Bayside Master Development Plan
 89 Elm Street, 196 Lancaster Street, 60 Elm Street, 315 Cumberland Avenue, 149 Lancaster Street, 195
 Lancaster Street, 163 Lancaster Street, 235 Oxford Street, 117 Preble Street, 81 Preble Street, 62 Elm Street,
 165-185 Lancaster Street
 Master Development Plan
 PL-002315-2022
 West Bayside Partners, LLC & Port Property Management, Applicants

| Submitted to: | Portland Planning Board | Prepared By: | Zach Powell, Senior Planner |
| Public Hearing Date: | June 13, 2023 | Date: | June 9, 2023 |

Figure 5: MDP Master Site Plan on Lancaster Street showing the proposed expanded sidewalks and plaza.

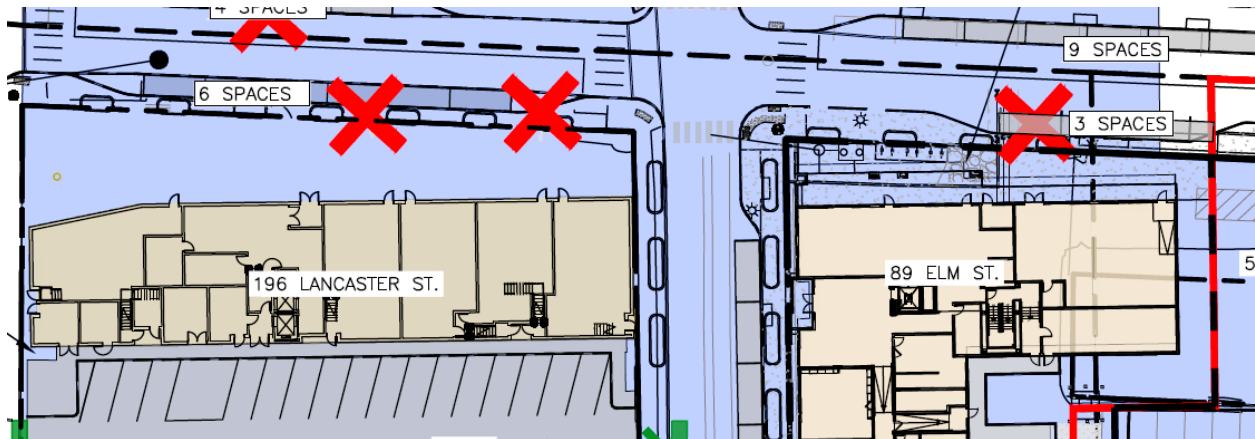
The Applicant is requesting, pursuant to §7.5.5.F.4, that the Planning Board allow the proposed buildings at 196 Lancaster Street and 89 Elm Street to have front setbacks greater than the B-3 zone maximum permitted front setback of 5 feet. The proposed buildings contemplate a front setback ranging between 13 – 40 feet along Lancaster Street. This expanded setback would allow the two proposed buildings to be developed in a manner that facilitates the creation of a linear publicly accessible open space along Lancaster Street.

- i. Provides substantial and viable publicly accessible open space or other amenity at the street level that supports and reinforces pedestrian activity and interest. Such amenities may include

Complies. The requested increased setbacks facilitate expanded sidewalk areas, outdoor eating spaces, and plaza space.

- ii. **Does not substantially detract from the prevailing street wall character by introducing such additional setback at critical building locations such as prominent form-defining corners, or create a sense of discontinuity in particularly consistent or continuous settings.**

Complies. Redevelopment of these parcels would define the street wall along the eastern side of Lancaster Street that currently lacks definition given that the majority of the frontage is occupied by surface parking areas. The proposed design for 196 Lancaster Street will provide a plaza that serves as a nexus for the MDP design with the woonerf, and 89 Elm Street will include an arcade that will enhance pedestrian facilities and meet the required setbacks on upper stories. Both of these setbacks help to support the goal of the project to establish Lancaster Street as a main thoroughfare for the project and enhance pedestrian activity.

- iii. **Does not detract from existing publicly accessible open space by creating an excessive amount of open space in one (1) area or by diminishing the viability or liveliness of that existing open space.**

Complies. The proposed setback for 196 Lancaster Street enables the development of one of the two open spaces for the project area, while the arcaded setback at 89 Elm Street will serve a complementary function to the proposed passive recreation space proposed at 163 Lancaster Street. These enhancements to Lancaster Street introduce open space in an area of the Bayside neighborhood with limited open space options and enhance connections to proximate open spaces such as the Bayside Trail, Deering Oaks Park, and Monument Square.

- iv. **The area of setback is of high quality and character of design and of acceptable orientation to solar access and wind impacts as to be attractive to pedestrian activity.**

Complies. The expanded sidewalks and open space will function as an attractive improvement for pedestrian activity along Lancaster Street and will enable positive building and site features.

Based on the compliance with these review standards, Staff recommends approval of the proposed expanded setback.

Figure 6: Shared Street Cross-Section Shaded to Indicate portions of woonerf proposed to be completed in Phase 1b (Shown in Red) and Phase 5a (Shown in Gray).

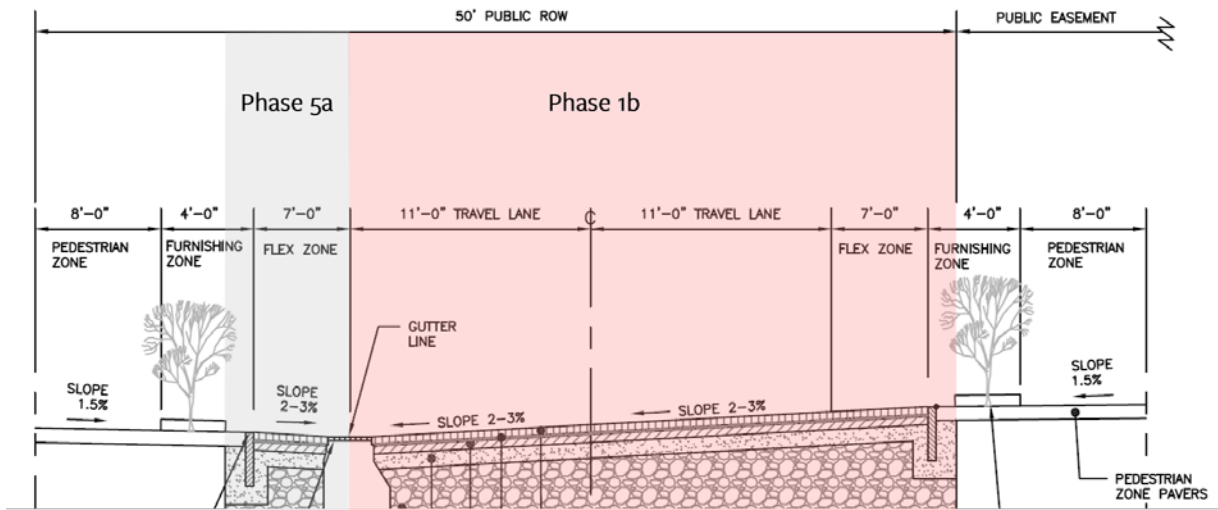
Updated phasing plan materials (P11-P14) document how and where construction will occur during each sub-phase. In particular, the materials provide more definition to the proposed implementation of the woonerf on Lancaster Street. As proposed and shown in Figure 6, the eastern side of the woonerf would be constructed in Phase 1b up to the gutter line on the western side of the street, with an interim curbed condition for approximately six years until the review of Phase 5a. As part of Phase 5a, the woonerf would be completed on the western side of the street.

Continuing dialogue between the Applicant and DPW raised several questions related to the purpose, design, maintenance, phasing, and extent of the woonerf. The Applicant has submitted updated application materials (Attachments I, O, DD2, EE2) that clarify the intent and operations of the woonerf. Upon review of the updated application materials, the Department of Public Works has stated that they support the concept of a woonerf along Lancaster Street, with final design details and coordination to be made under site plan review. As part of the review for the MDP, a proposed waiver request has been submitted to allow a flush curb, when a 7” curb reveal is required in §1, Figure I-12 of the City’s Technical Manual.

The Planning Board [**finds/does not find**] based upon the Planning Staff's review that extraordinary conditions exist or undue hardship may result from strict compliance with Section 1, Figure I-12 of the Technical Manual which requires a 7" curb reveal, that substantial justice, and the public interest are secured with the proposed variation in this standard, and that variation is consistent with the intent of the ordinance. The Planning Board [**waives/does not waive**] Technical Manual §1, Figure I-12 to allow a flush curb along Lancaster Street between Preble & Elm Streets.
